PLANNING & ZONING COMMISSION

October 16, 2024 at 10:00 AM

RE: **Application for a Minor Site Plan: Fifth Third Bank, Mount Dora Groves South PUD (Project Name)**, 19160 US Highway 441, Mount Dora (Site Address); Andrew J. Hupp, One Oak MD Groves, LLC (Property Owner) Angelina Makwoski, BDG Architects LLP(Applicant); Nisit Sapparkhao, Infinity Engineering Group, LLC (Engineer); Patrick D. Cunningham, Infinity Engineering Group, LLC (Landscape Architect); Jack Marshall, BDG Architects, LLP (Architect).
Project No. SP24-08

Staff recommends approval of the above-referenced Site Plan request, subject to modification of proposed bicycle racks.

SHEET TITLE	
ELECTRICAL PHOTOMETRIC SITE PLAN	
SHEET NUMBER

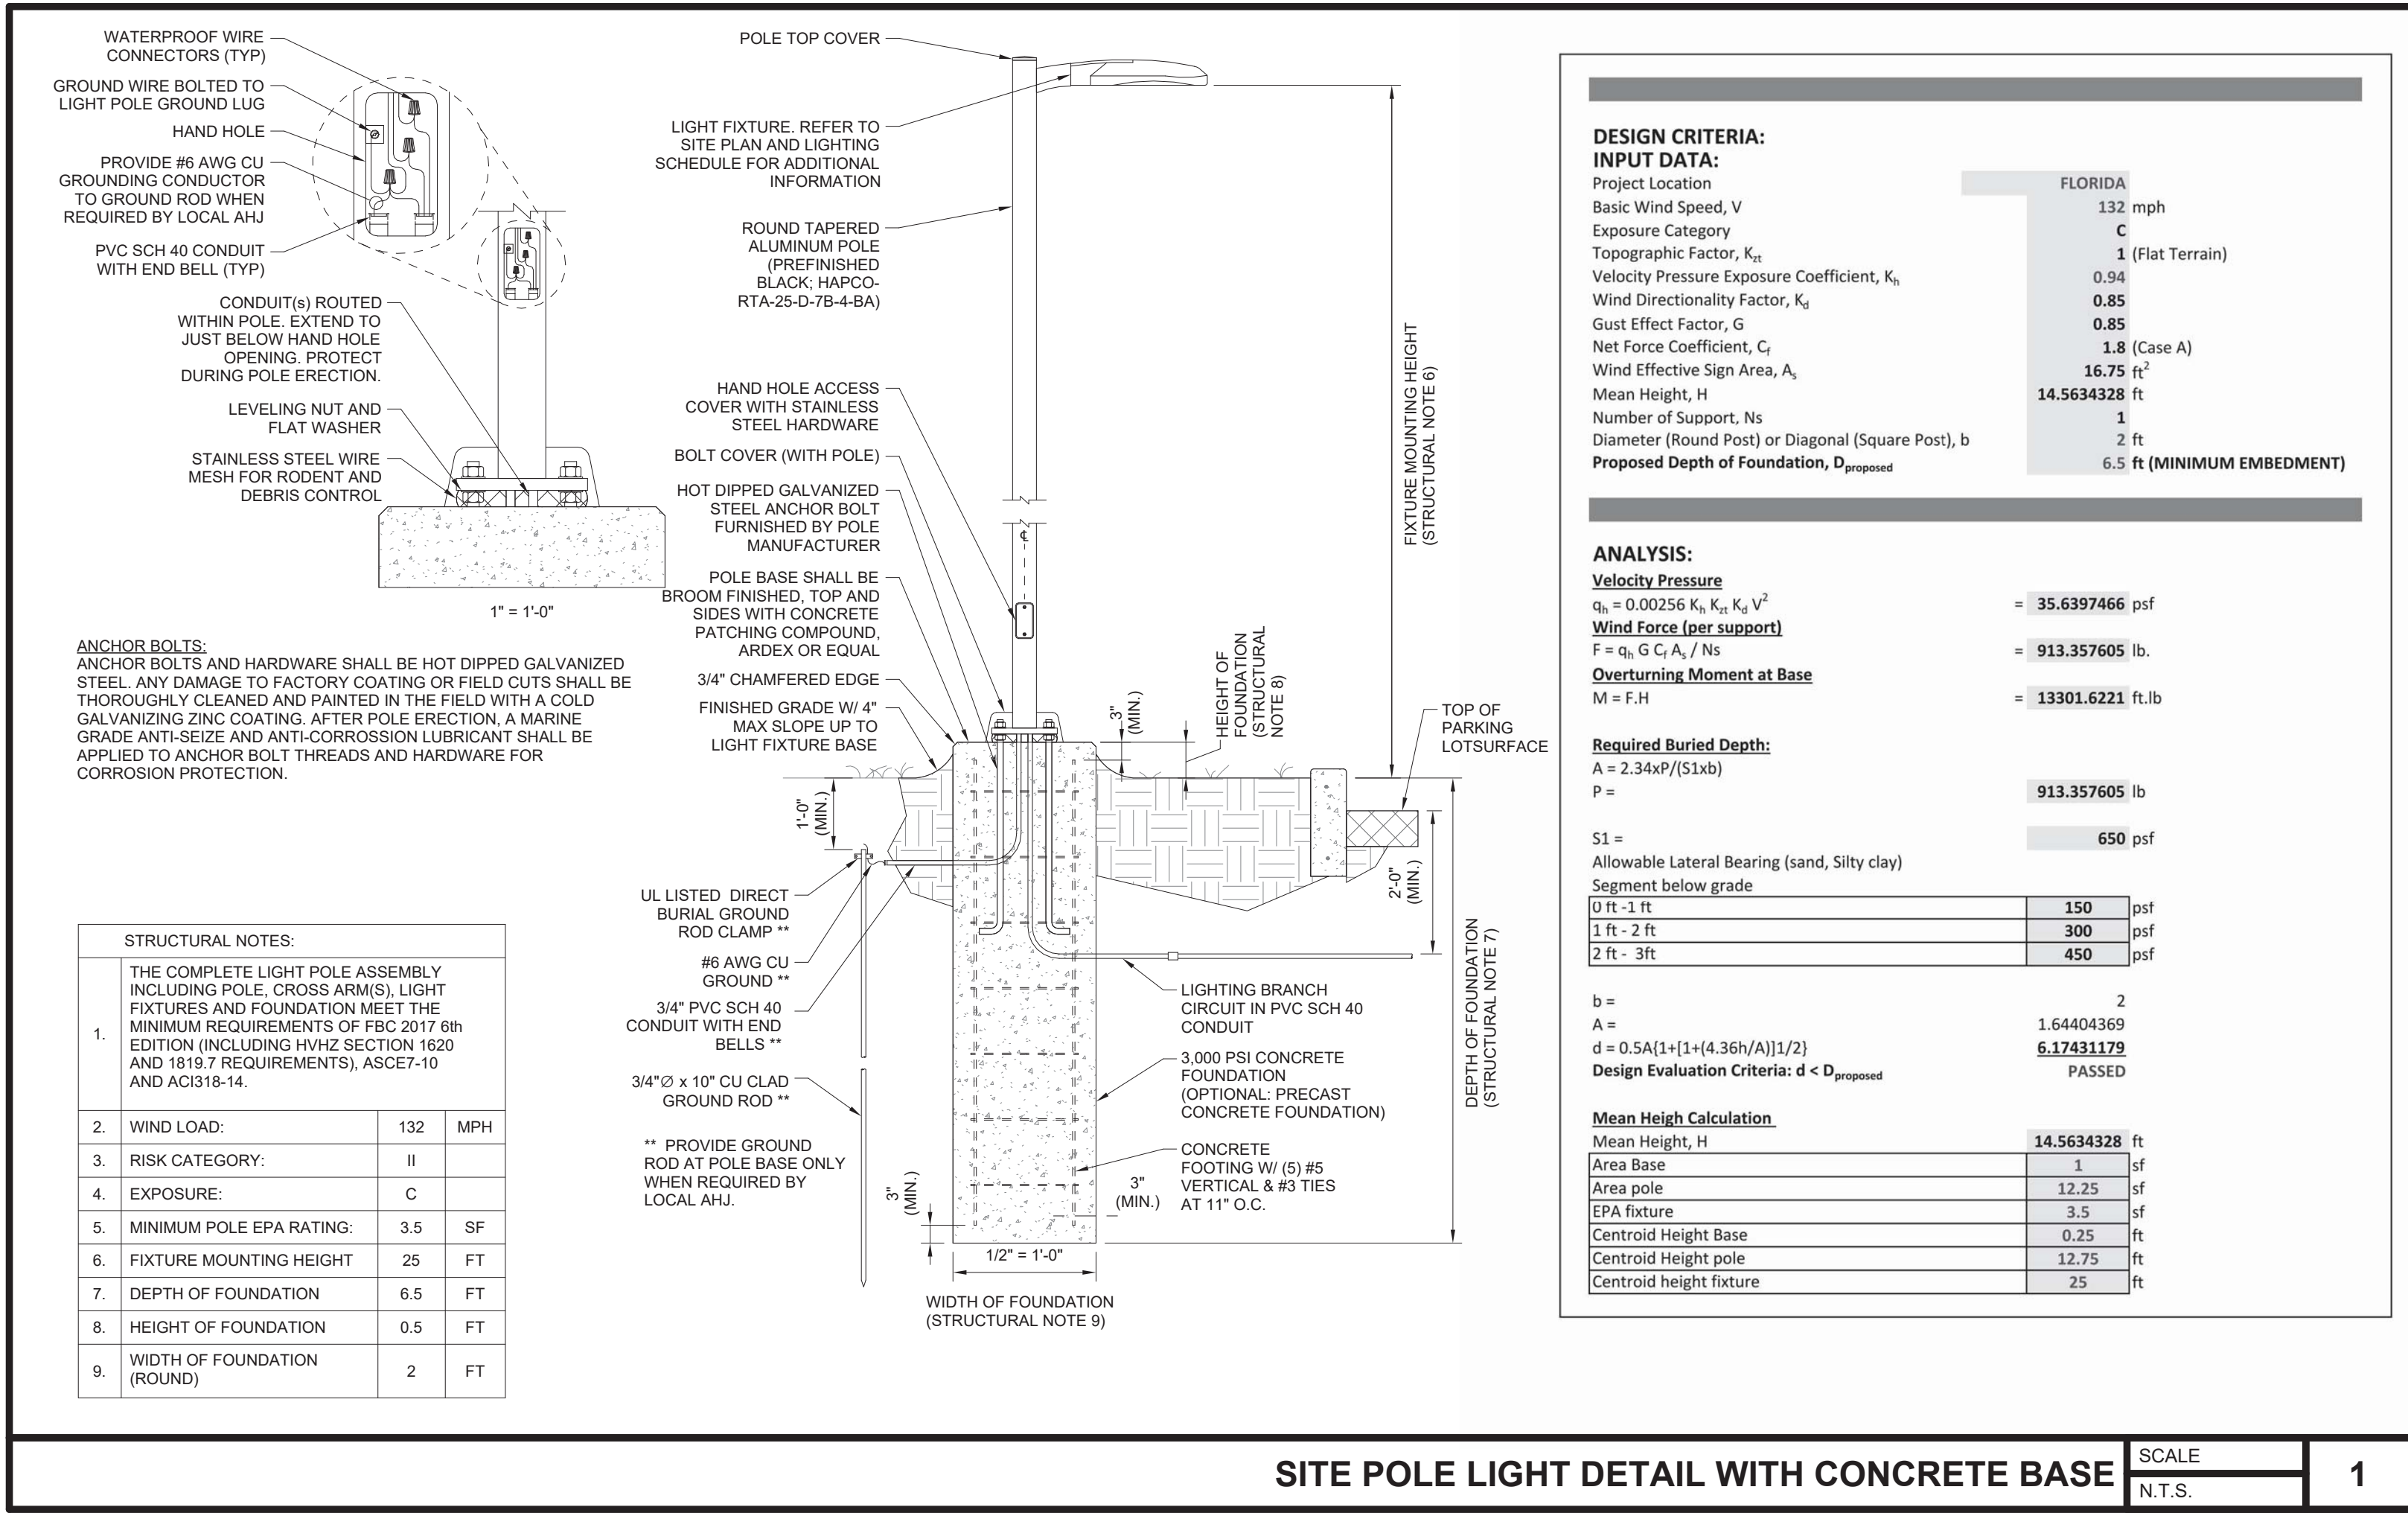
2. Provide photometric plan as indicated on site plan submittal guide. **The Response to Staff Comments states refers to Plan Sheets E-011 but this sheet was not provided in the civil nor architecture plan sets.**

UTILITY PLAN

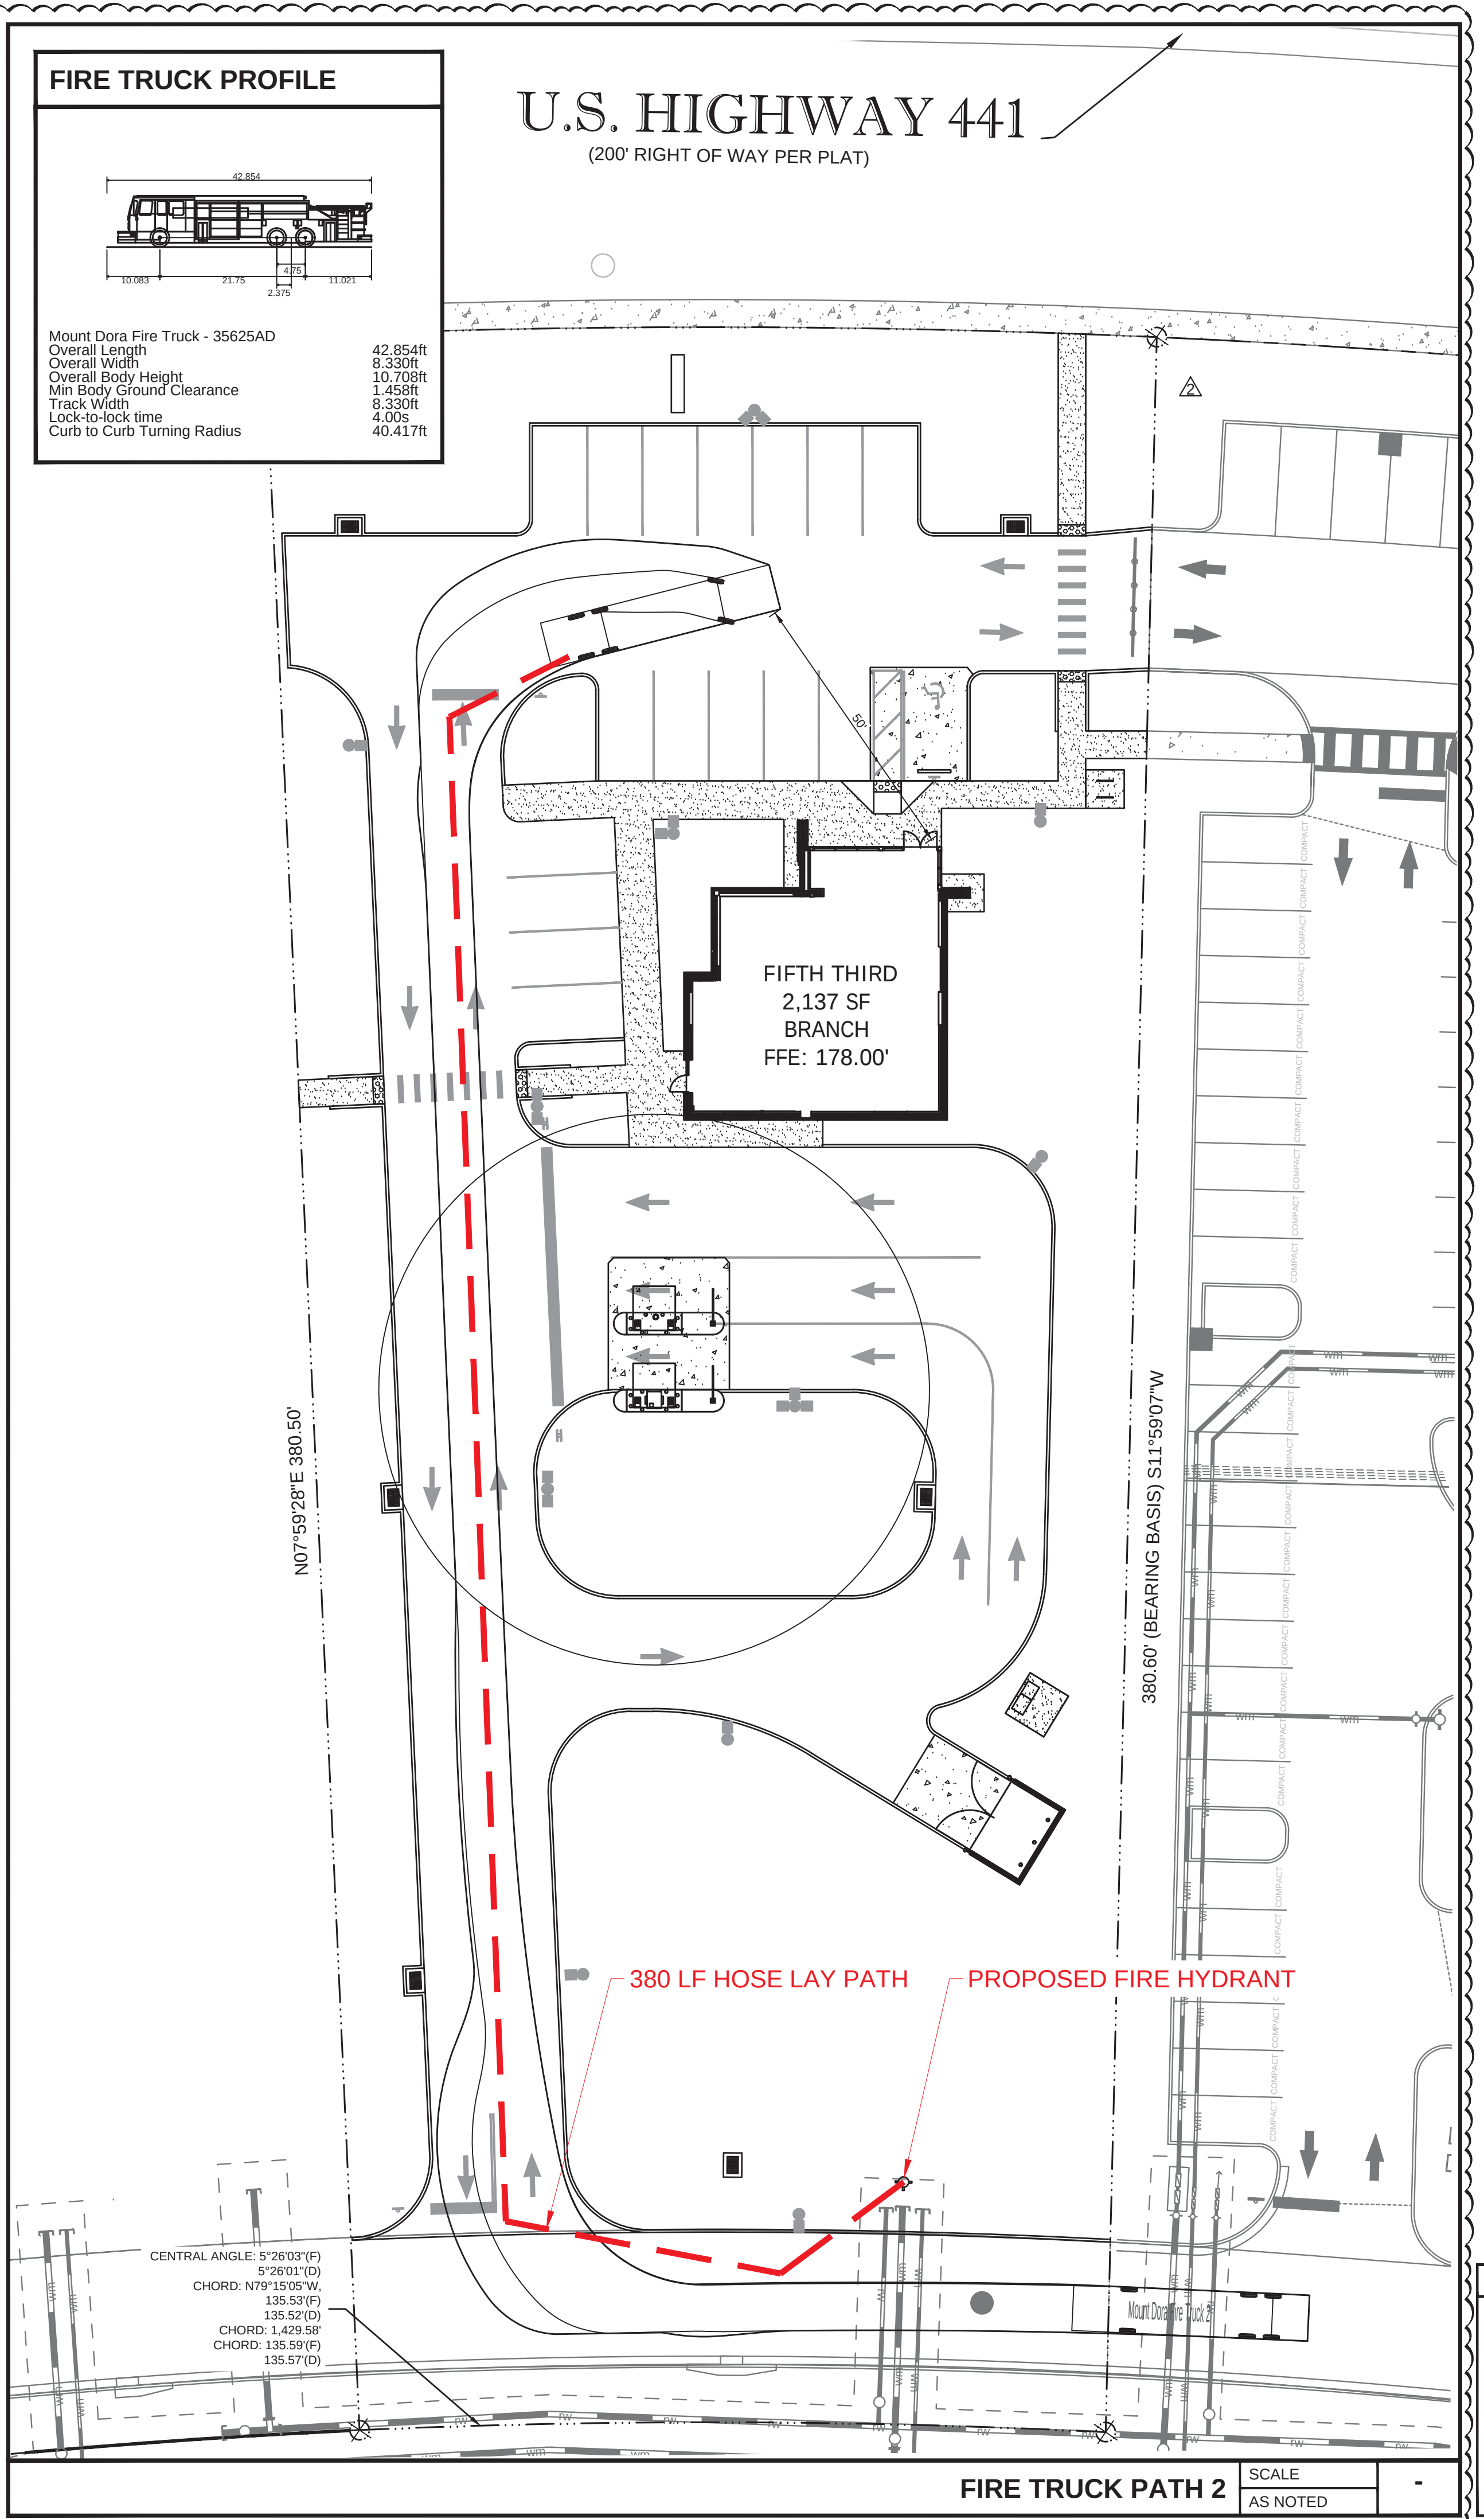
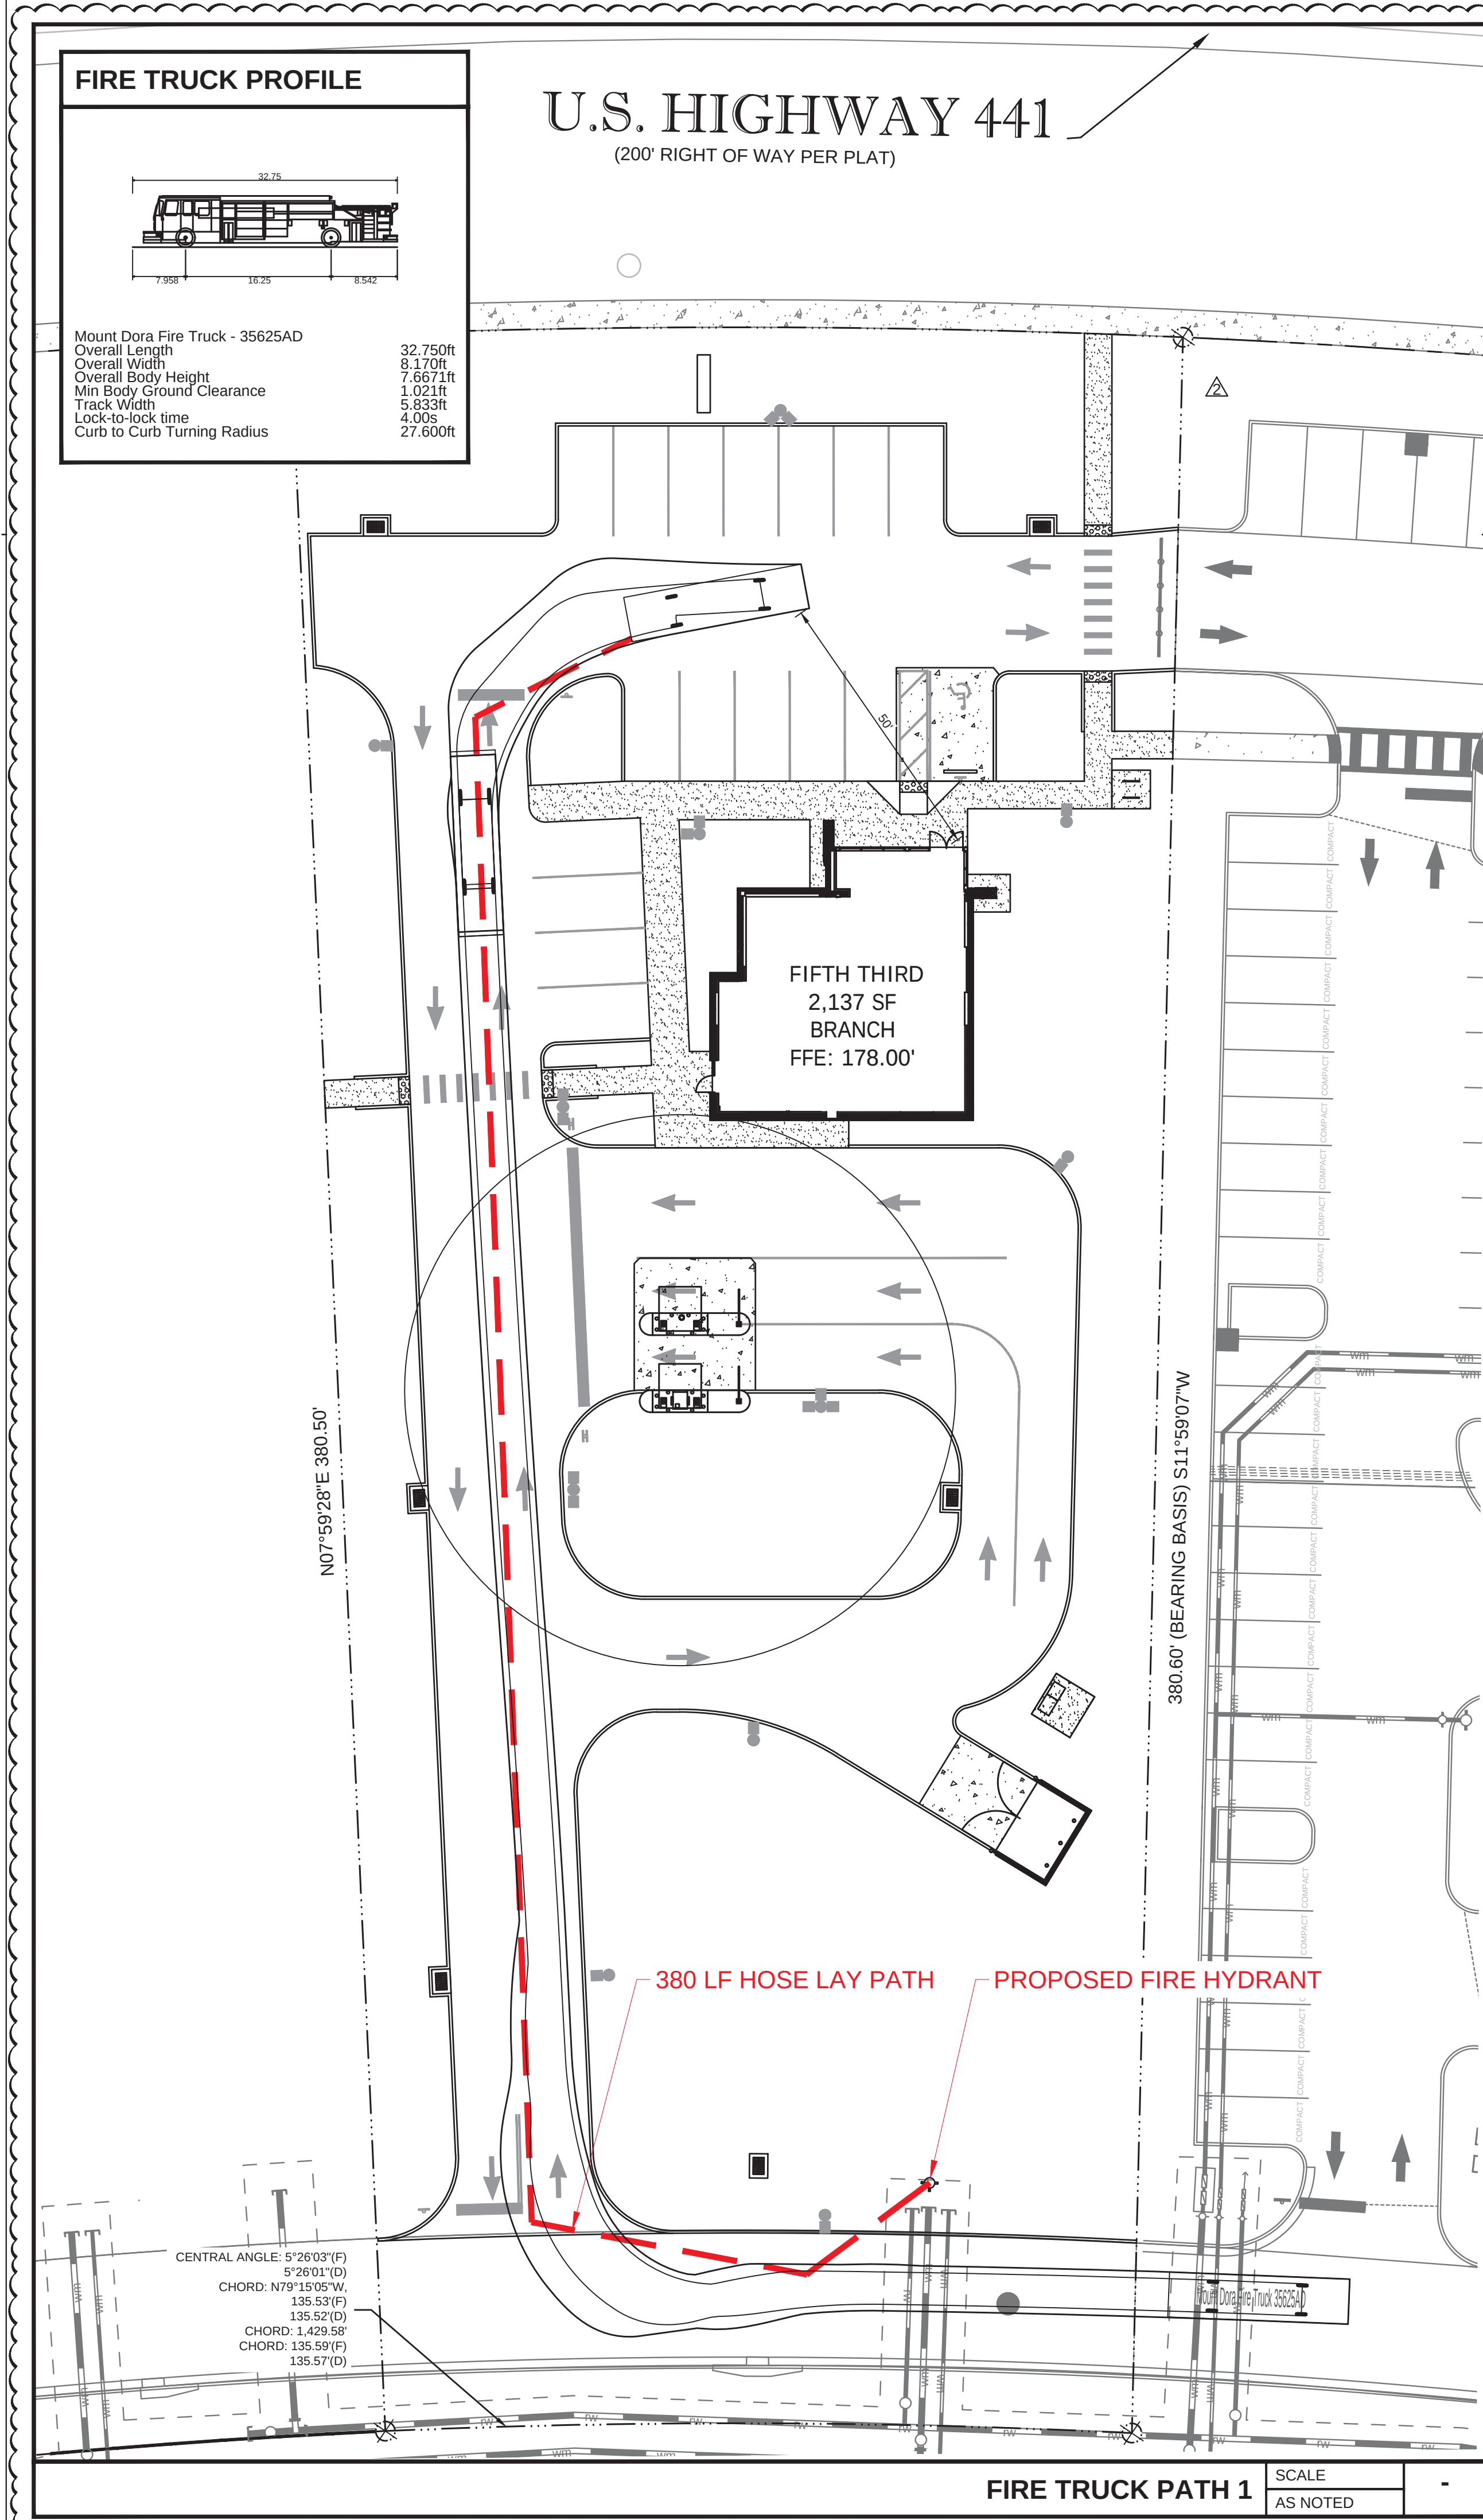
1. Plan Sheet C00.01: Include an item under “Water System Notes” for disinfection to be performed in accordance with ANSI/AWWA C651
2. Plan Sheet C-04.01: Irrigation is not part of the City of Mount Dora infrastructure and is potentially in the way of servicing utilities. Move irrigation well outside of utility easement and away from the sanitary sewer line
3. Plan Sheet C-04.01: Utility System Data section calls out in Irrigation i1 & i2 reclaimed water connection and meter. Is the irrigation from the irrigation well or Mount Dora Utilities?
